1988 - 1990 Corvette: Service Bulletin: Power Steering Shudder / Groan

Subject: POWER STEERING SHUDDER/GROAN INSTALL P/S COOLER & HOSE

Model and Year: 1988-90 CORVETTE WITH 5.7L ENGINE

Bulletin Number: 90-376-3B - (10/25/1990)

STEP E

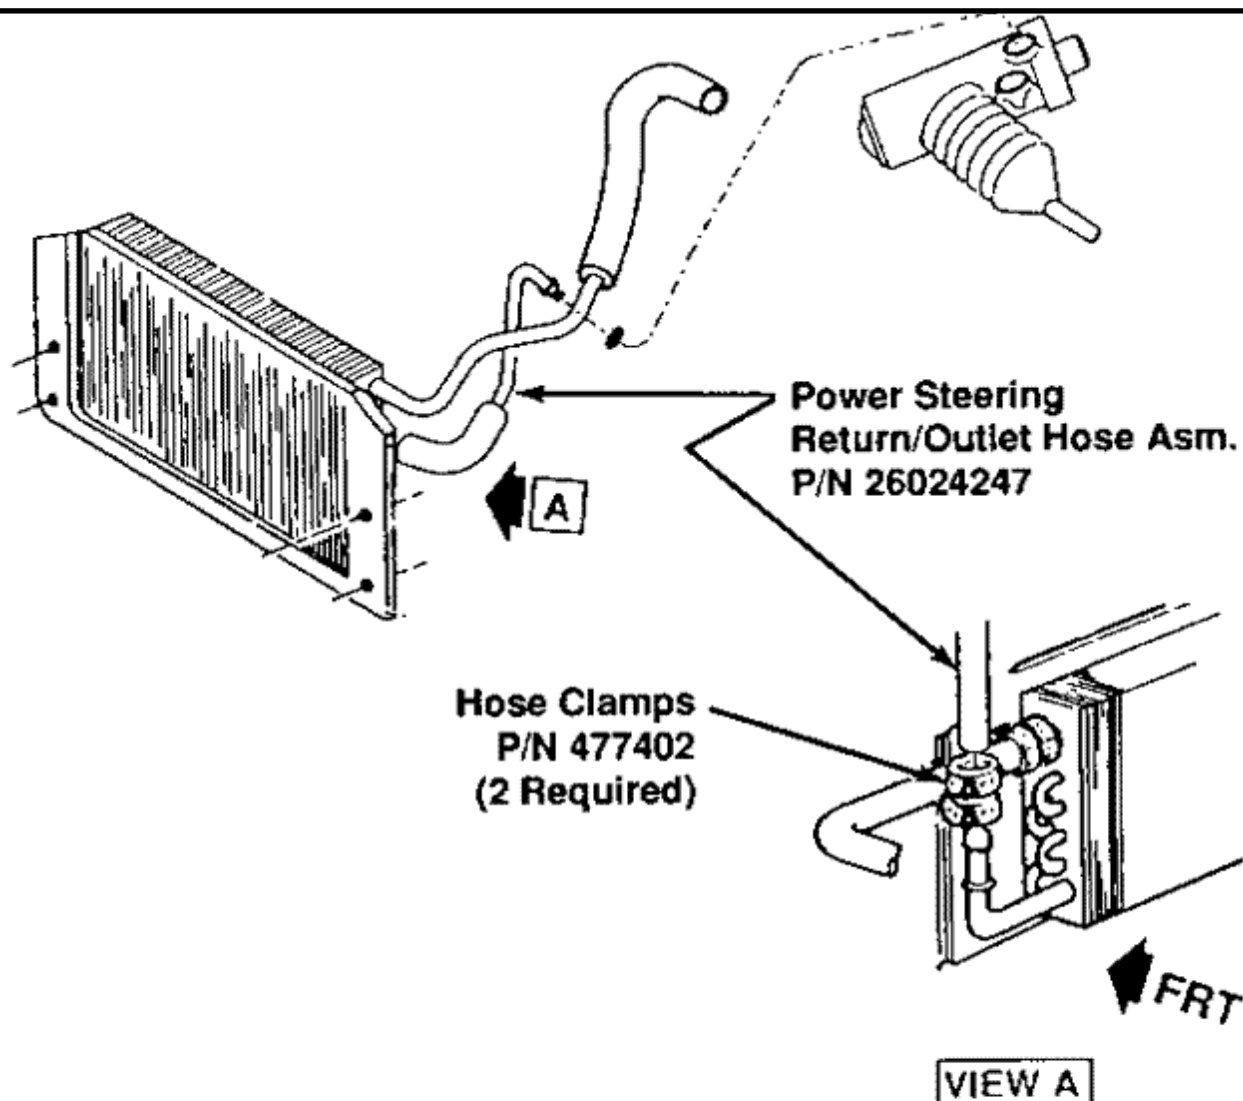
On applicable 1990 vehicles as designated by VIN breakpoints indicated in step matrix, replace existing power steering gear.

Step A Illustration

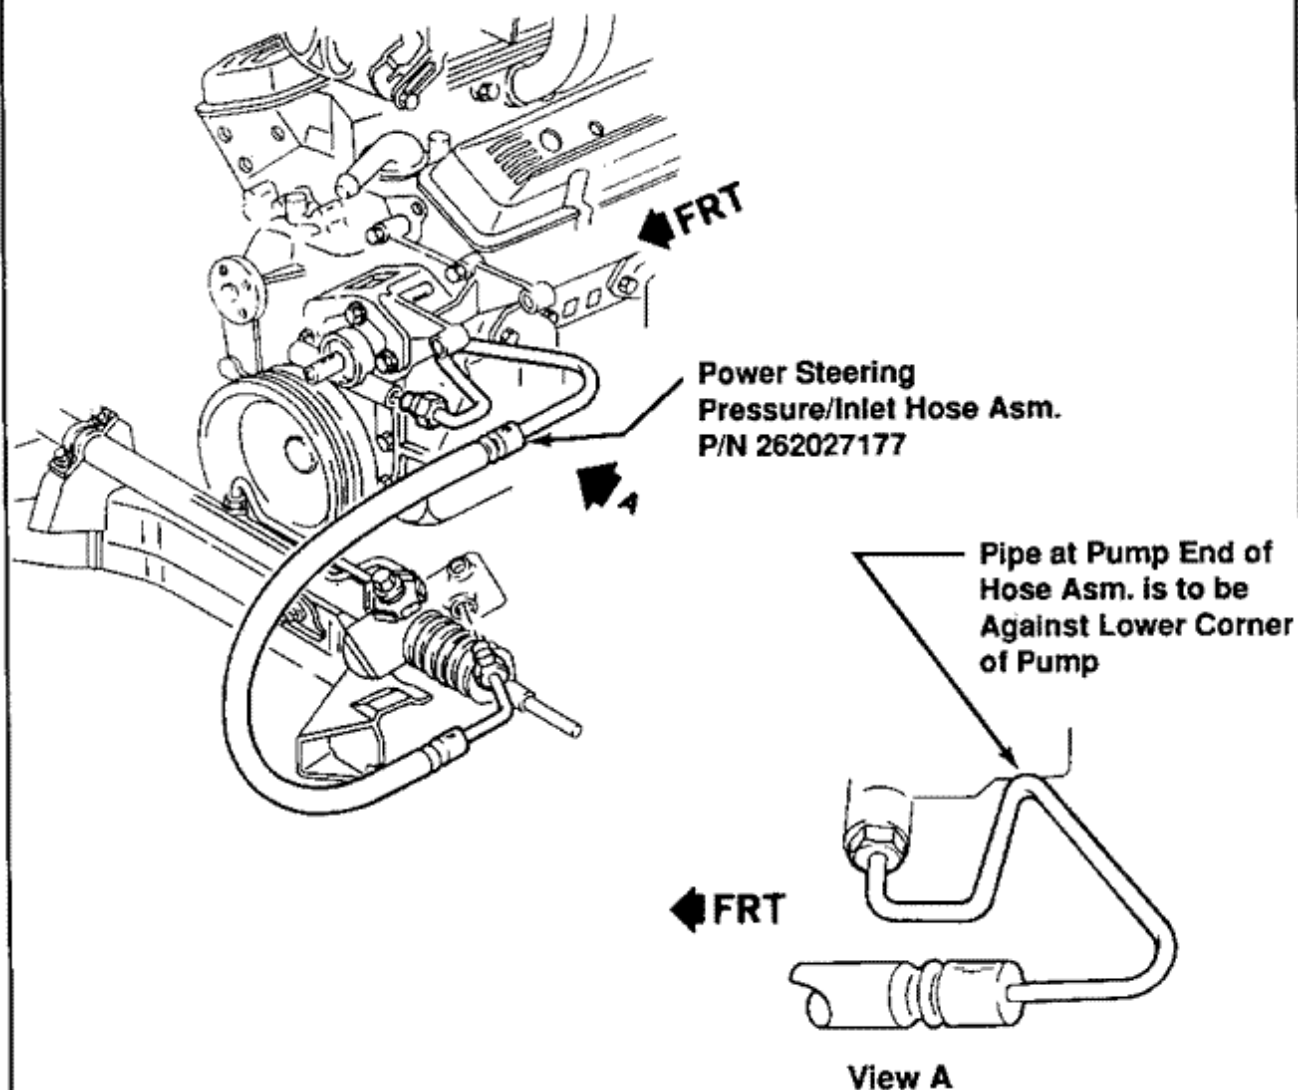
Replace existing return hose (steering gear to cooler) with new assembly with internal tuner cable.

Fitting (Return/Outlet Hose) – 28 N•m (21 lbs. ft.)

Clamps (Hose) – 2.5 N•m (22 lbs. in.)

Step B Illustration

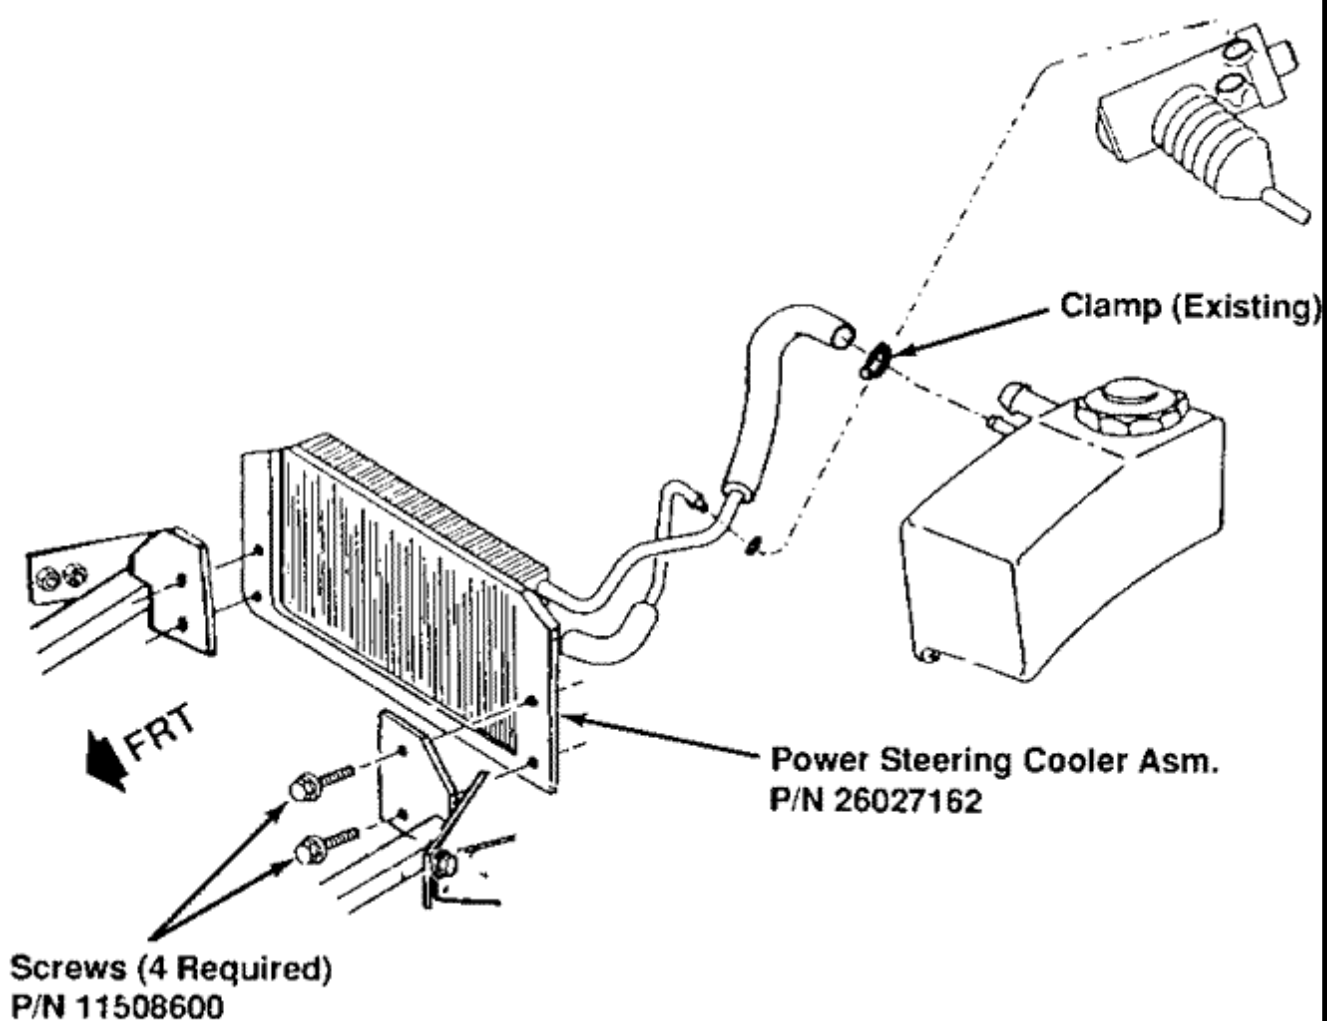
Replace existing pressure/inlet hose (pump to steering gear) with new assembly with internal tuner cable.

Torque Specifications
Fittings (Pressure/Inlet Hose) – 28 N•m (21 lbs. ft.)

Step C Illustration (1990 Vehicles)

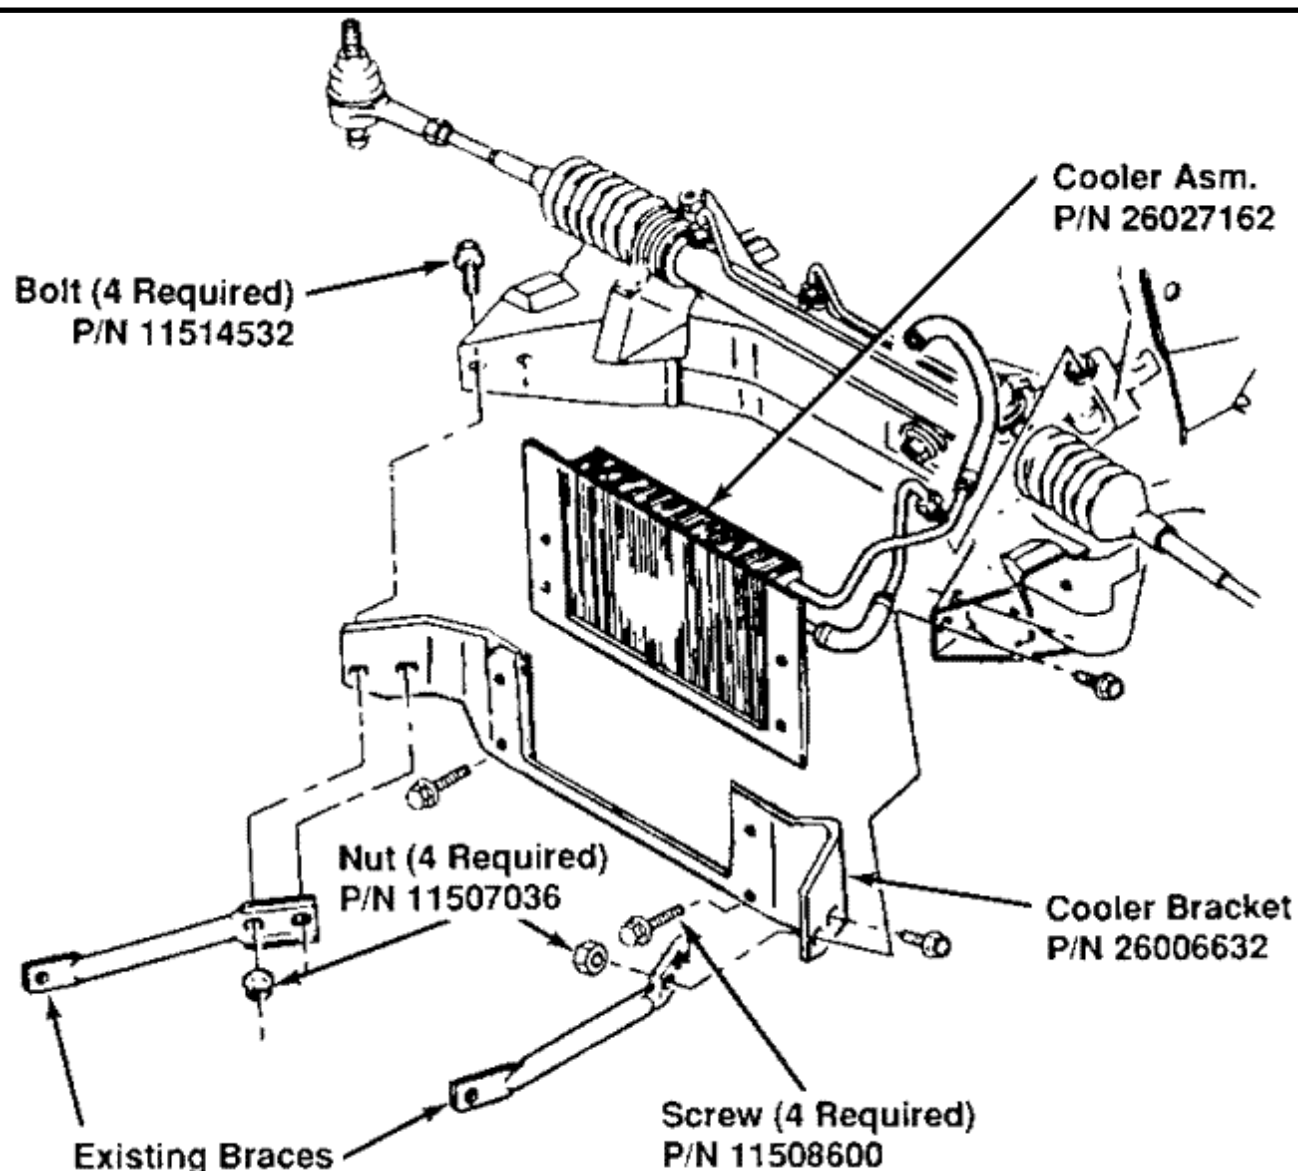
Replace existing power steering loop/pipe cooler with finned cooler that includes return hose with tuner cable.

Fitting (Return/Outlet Hose) – 28 N•m (21 lbs. ft.)

Clamp (Reservoir Hose) – 2.5 N•m (22 lbs. in.)

Screws (Cooler/Bracket) – 10 N•m (89 lbs. in.)
